FLORENCE AVENUE TOWNHOME PROJECT

FINAL INITIAL STUDY/
MITIGATED NEGATIVE DECLARATION

Date: January 5, 2022
Prepared by: Renee Escario
To: Jimmy Wong, Associate Planner, City of Santa Fe Springs
Project: Florence Avenue Townhome Project
Subject: **CEQA Review of the Proposed Modified Project**

Modified Project Site Plan

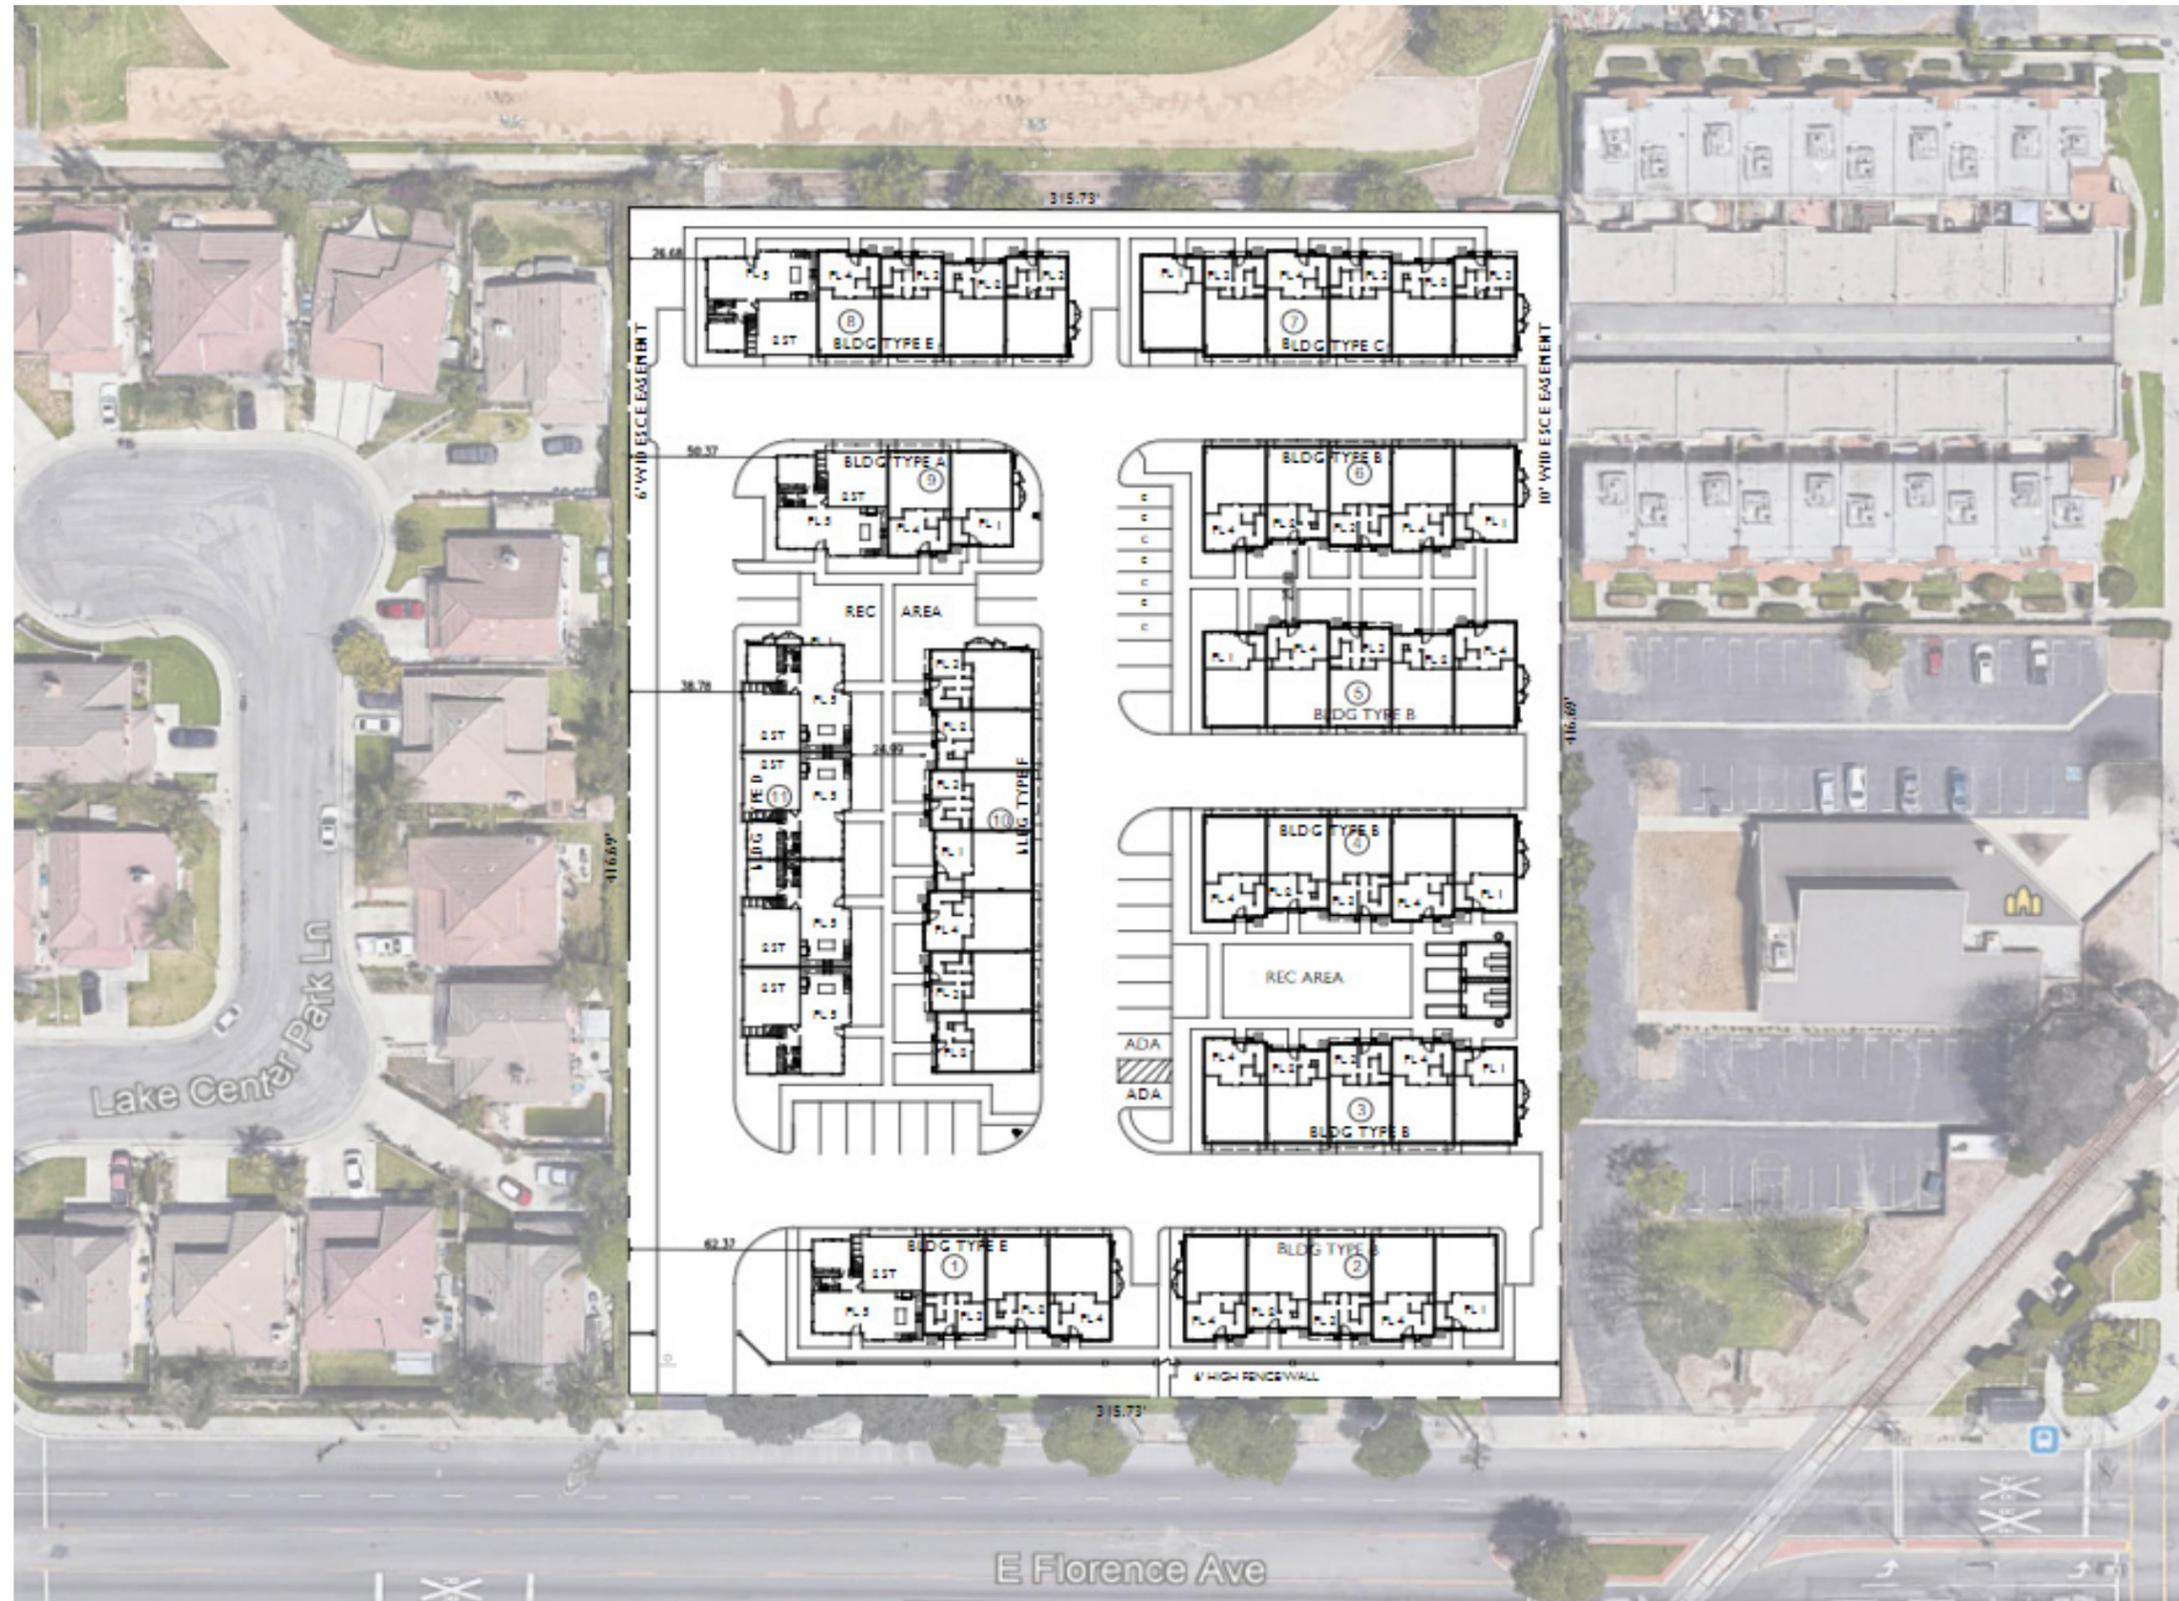
The proposed Modified Project would reduce the number of residential units, the height of the residential structures along the western portion of the site and increase the number of open parking spaces.

The proposed modified site plan reduces unit count proposed from 63 units to 54 dwelling units, which is a reduction of 9 residential units (a 14.3 percent reduction). The residential structures along the western portion of the site would consist of seven 2-story attached townhomes, adjacent to the existing single-family residences to the west, and the remainder of the site would be developed with 47 3-story attached townhomes. This would result in a reduction in structure height along the western portion of the site from 35 feet to 23 feet 6 inches in height.

The Modified Project would increase the number of open parking spaces on the site from 22 open stalls for 63 residences to 34 open stalls for 54 residences. The open stalls in addition to the attached 2 car garage for each residence would result in a total of 2.63 parking spaces per dwelling unit, which exceeds the Municipal Code requirement of 2 spaces per residence.

The modified site plan results in a slight decrease in lot coverage, a slight increase in the amount of total open space per residential unit, and slight increase in building setback from the western site boundary. All other aspects of the proposed project would remain as originally proposed, including on-site circulation, types of recreation amenities, landscaping, walls, and utility provision. Table 1 provides a comparison between the Original Project as evaluated in the MND and the proposed Modified Project.
